# VILLAGE OF ORLAND PARK

### Plan Commission

Tuesday, March 5, 2019

[2018-0742](#) Ashburn Baptist - Teen Addition - Development Petition for Rezoning, Site Plan, Elevations, Landscape Plan, Special Use Permit

SHEET NUMBER:  
**A201**

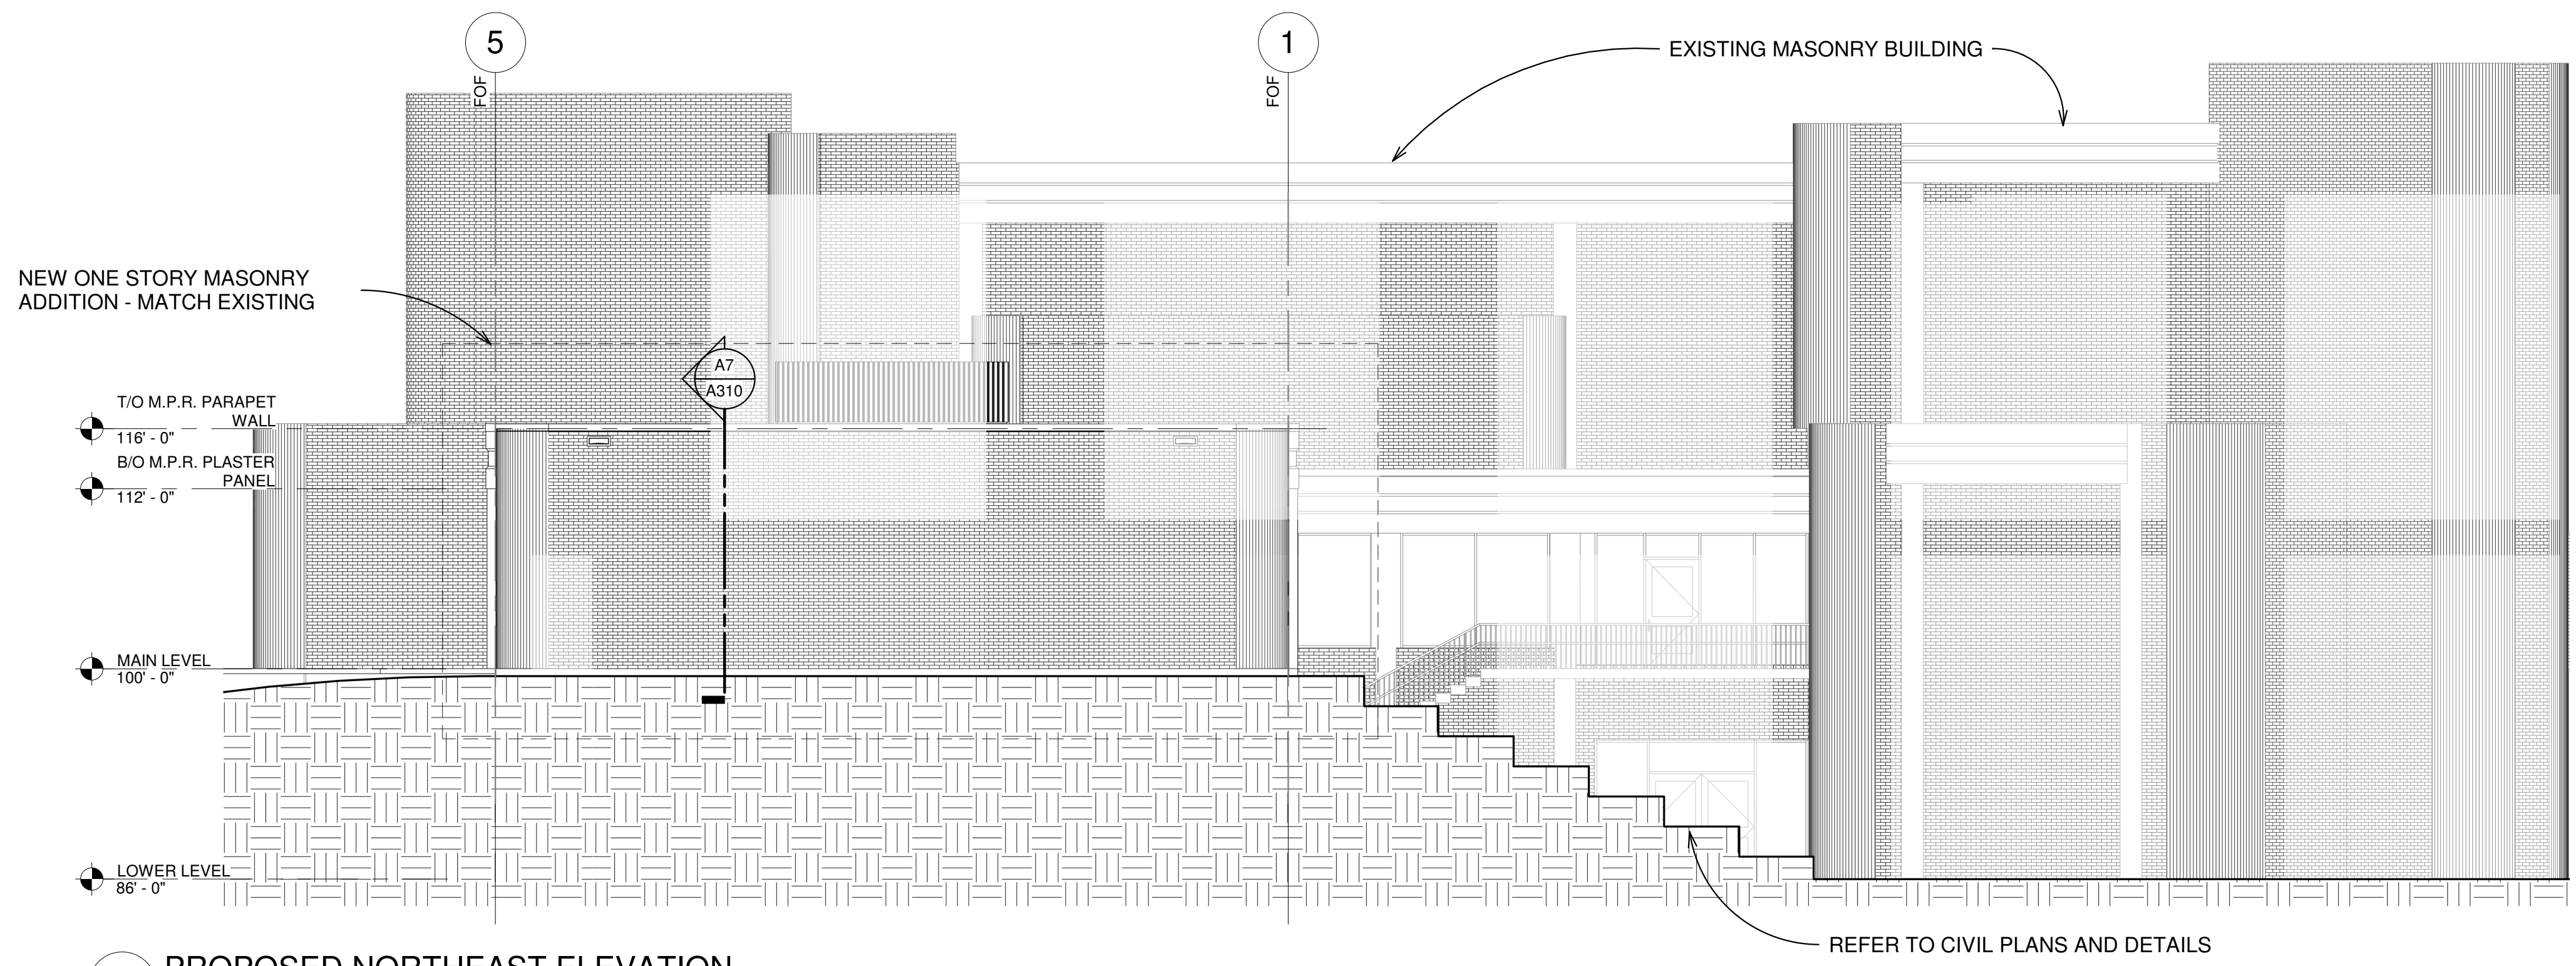
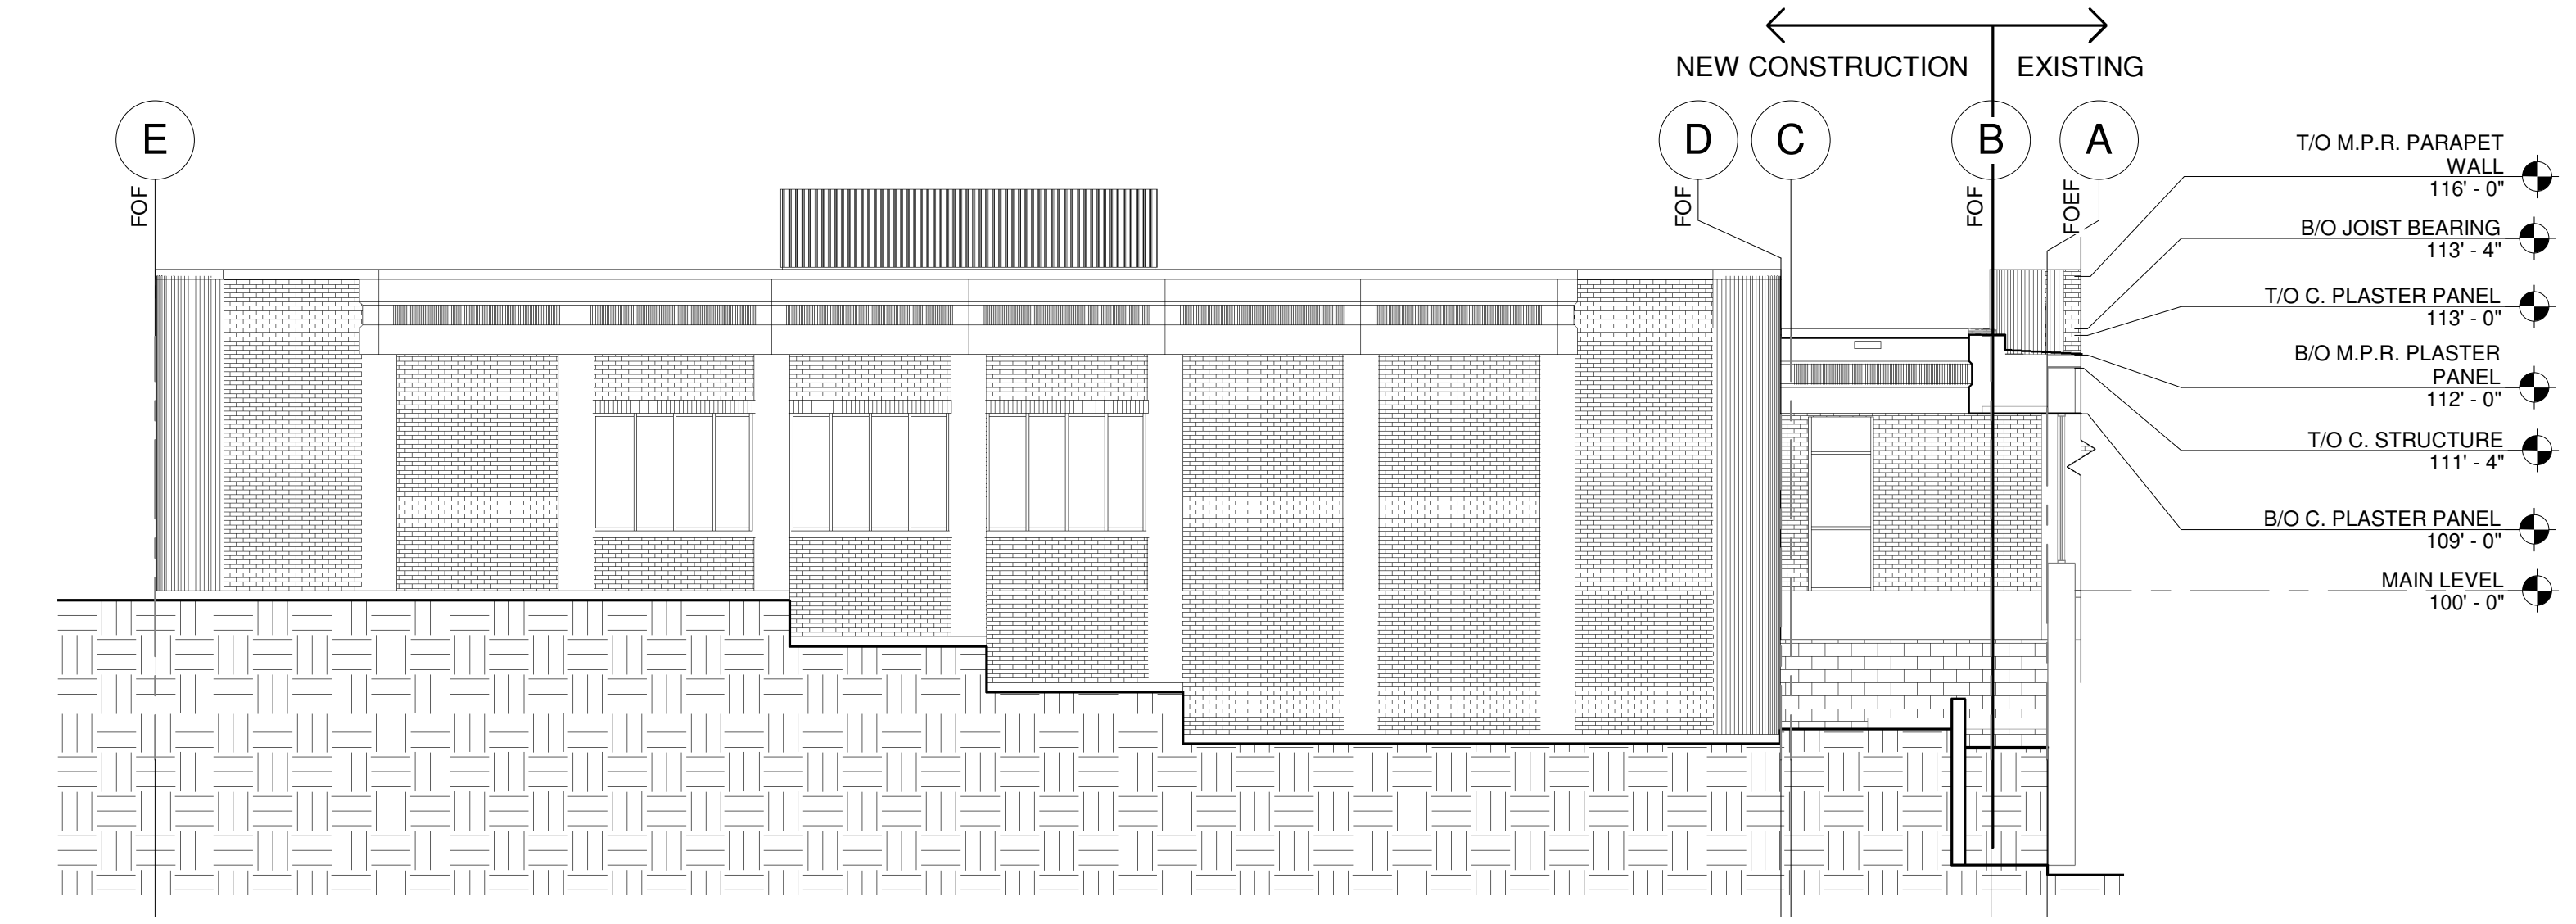
Rooftop mechanicals will be added to the teen addition. The petitioner proposes a 48" tall metal panel box that matches the building color, to screen the equipment. The proposed 'roof top curb adapter' is specifically designed for the mounting and screening of HVAC rooftop equipment.

1. Rooftop screening must match the proposed brick and trim color as closely as possible.
  2. A Final Landscape Plan must be submitted for review and approval subject to the following condition:
    - a. Add at least 11 additional shrubs plus perennials along the northwest addition façade in the tiered foundation beds to meet Code.
  3. Any new Signage will require separate Sign Permit approvals.
  4. No new retaining wall shall exceed 3' in height.
  5. Screen all new rooftop mechanicals from view.
  6. Meet all final engineering and Building Division requirements.
-

**Asburn Baptist Church - Teen Addition**  
 15401 Wolf Road  
 Orland Park, IL  
**Landscape Plan**

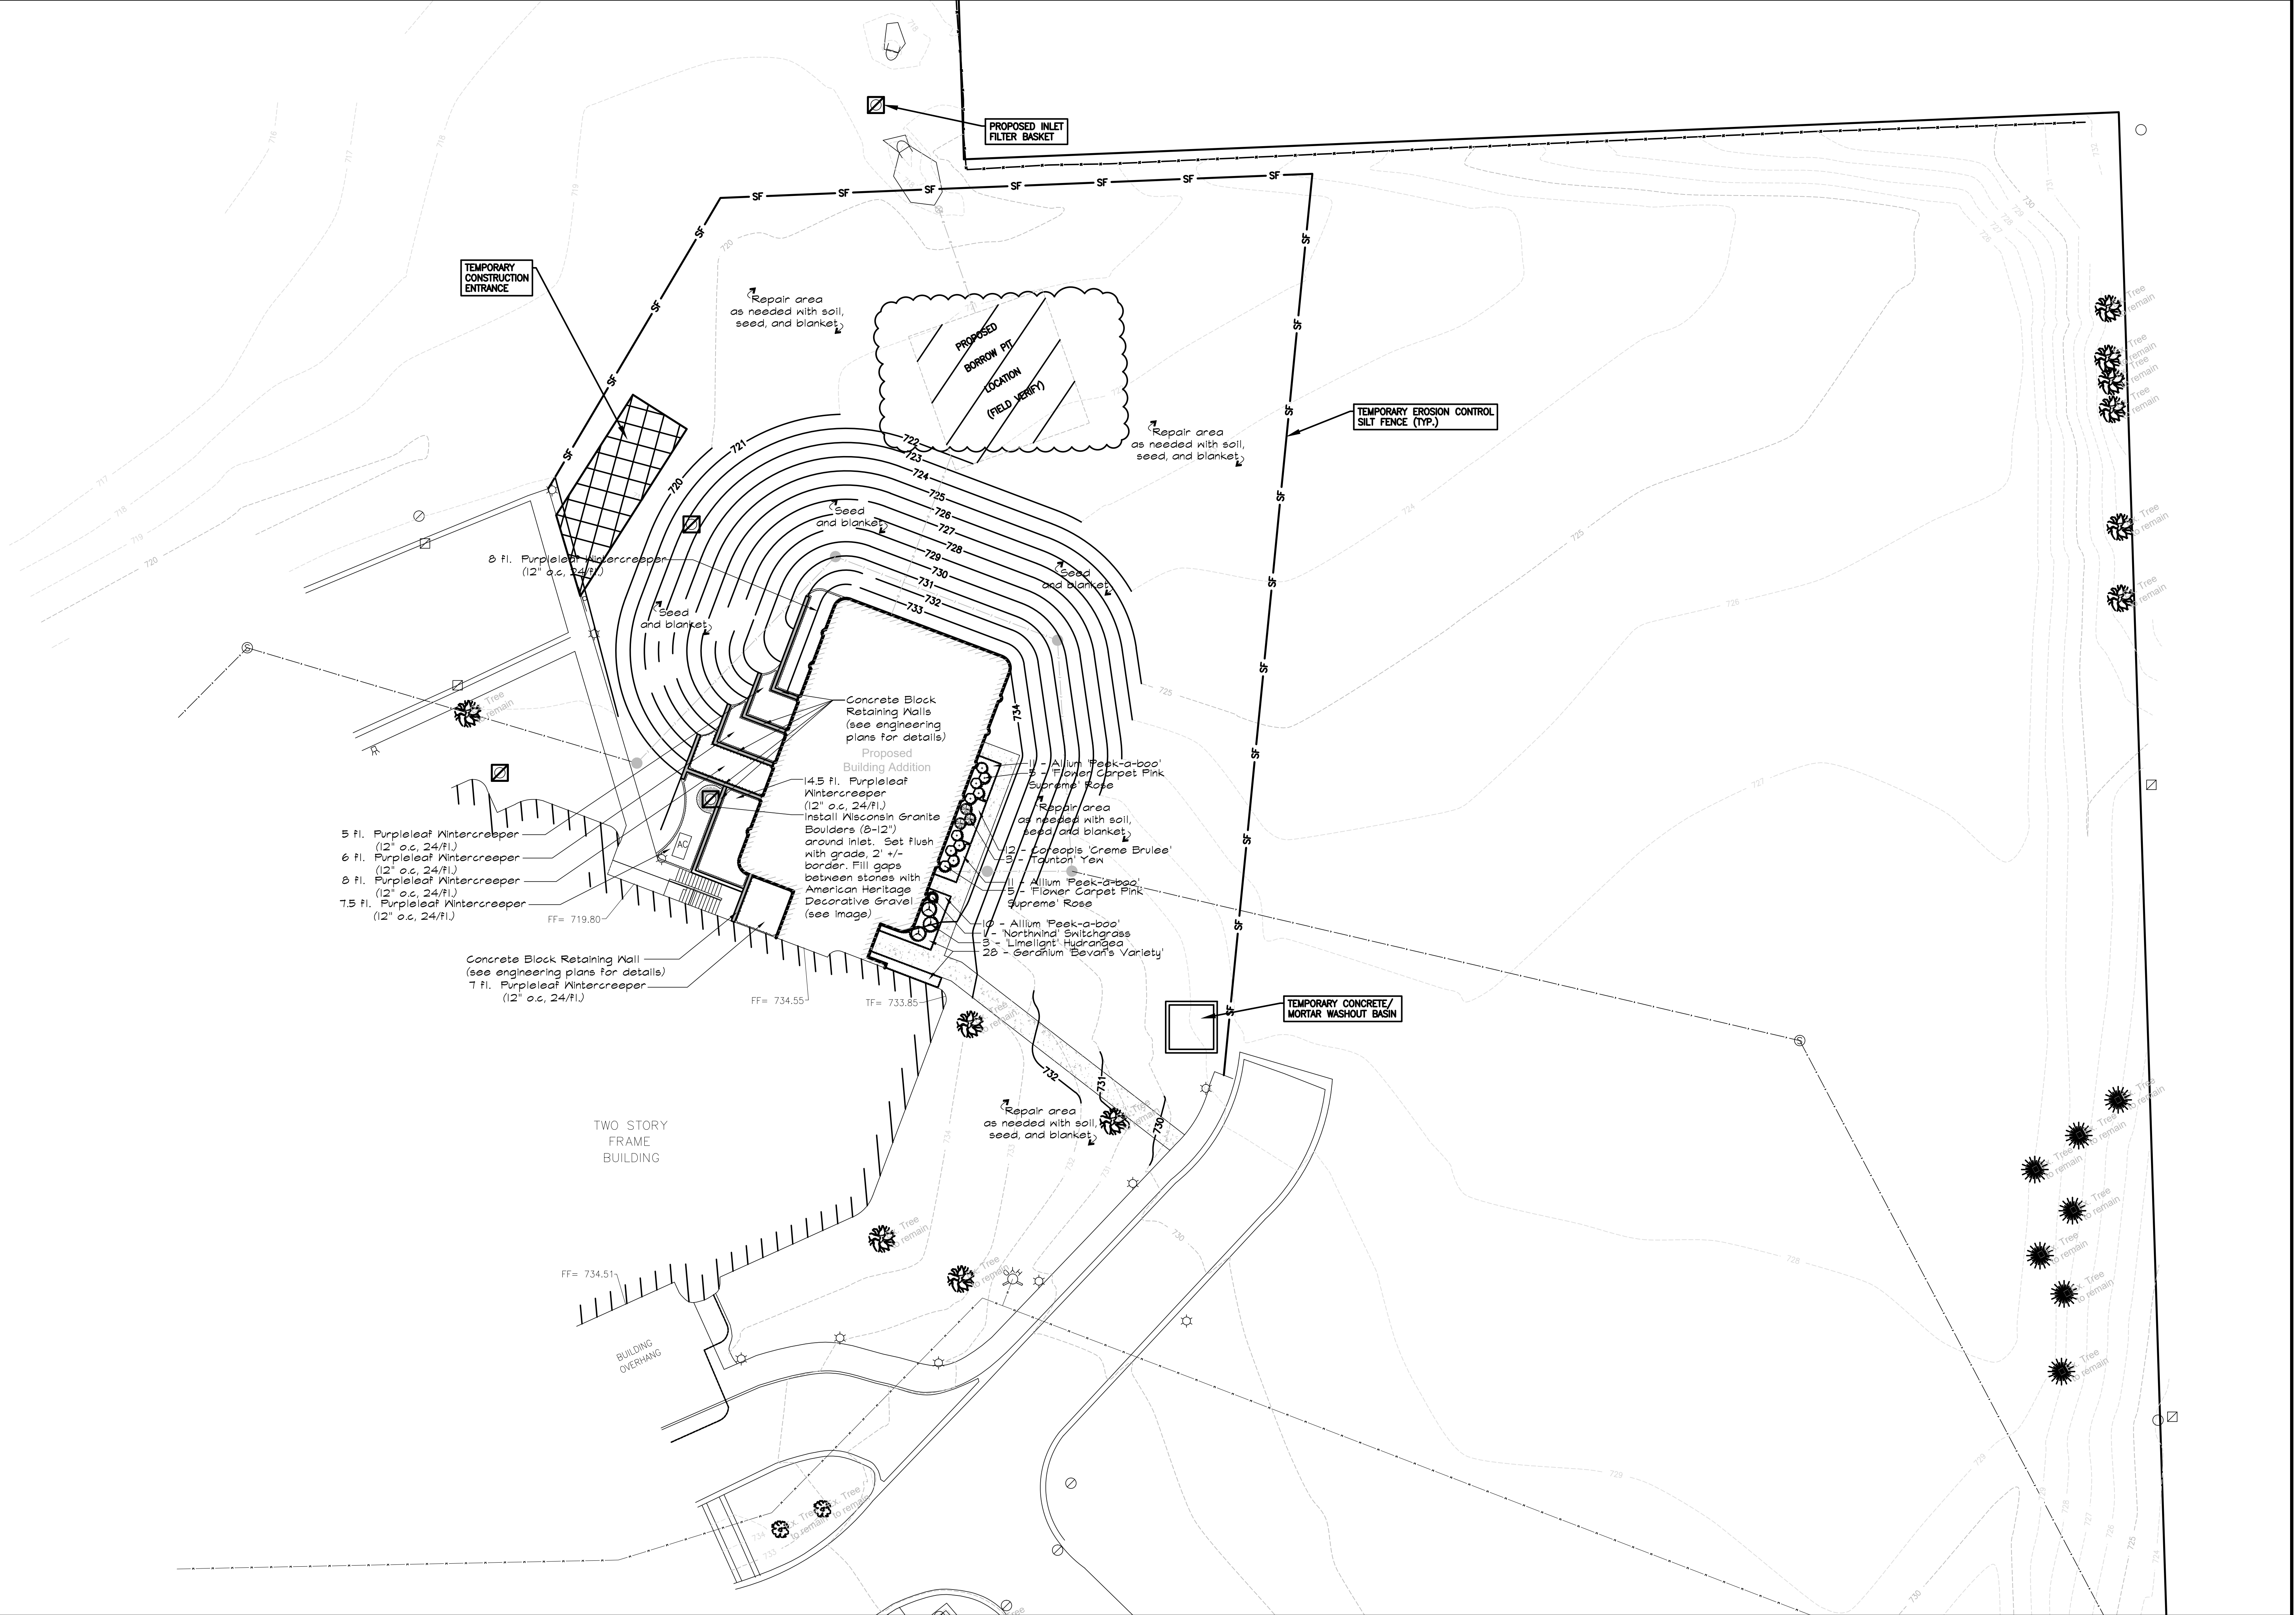
A preliminary landscape plan has been submitted, showing proposed shrubs and perennials along the southeastern elevation. However, in this situation, the Code requires a 7' wide foundation planting along 50% of the building. The perimeter of the building is 219 linear feet, therefore **110 linear feet** of foundation plantings is required, while only **60 feet** of foundation plantings have been provided. The **additional 50 linear feet** must include a combination of trees, shrubs, and perennial ground covers, including at least 11 shrubs. It is recommended these shrubs be placed on the northwest side of the addition in the tiered beds.

1. Rooftop screening must match the proposed brick and trim color as closely as possible.
2. A Final Landscape Plan must be submitted for review and approval subject to the following condition:
  - a. Add at least 11 additional shrubs plus perennials along the northwest addition façade in the tiered foundation beds to meet Code.
3. Any new Signage will require separate Sign Permit approvals.
4. No new retaining wall shall exceed 3' in height.
5. Screen all new rooftop mechanicals from view.
6. Meet all final engineering and Building Division requirements.
